## Product Change Notice (PCN)

PCN Number: PCN-0455008R

Product(s) Affected: PJ-036BH-SMT-TR

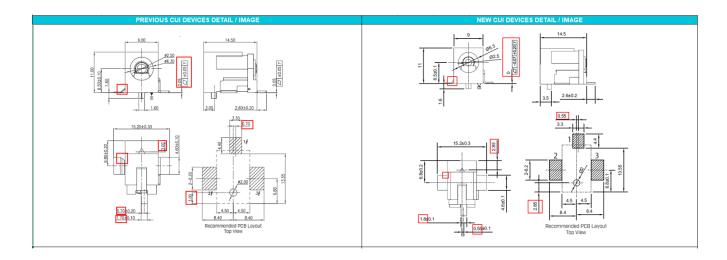
Description of Change: Product re-engineered for improved manufacturability and production yield. Coplanarity specifications changed. Shape of terminal 2 changed. Location and size of terminal 1 changed. Locating post PCB hole location changed. See image below for reference and check CUI Devices website for updated drawing. Cosmetic differences may be visible and not affect the form fit and function of the product.
